DOCUMENT NO: OP-1903.066

TITLE: EMERGENCY RESPONSE FACILITY -
OPERATIONAL SUPPORT CENTER (OSC)

REVISION NO: 012-01-0

CHANGE NO: PC-01

1903.066A

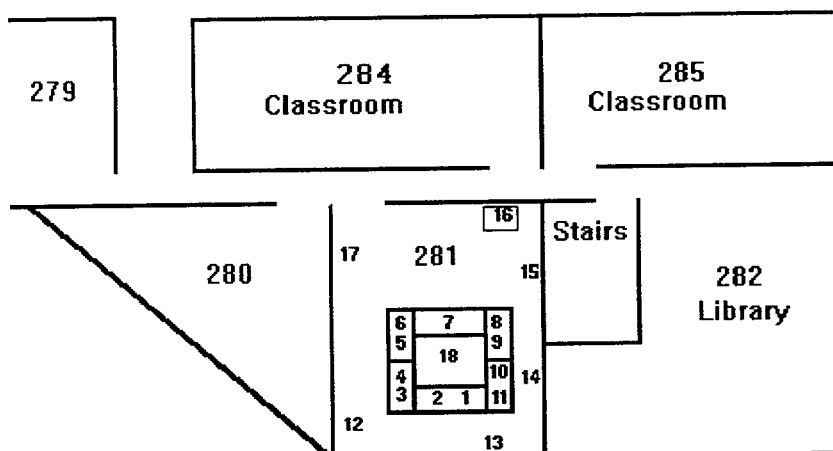
1903.066A OSC Layout Diagram	Replaced old diagram with a new one which depicts the new forms filing cabinet and the relocation of Emergency Kit C.		
FORM TITLE: DESCRIPTION OF CHANGE		FORM NO. 1000.006C	CHANGE NO. 050-00-0
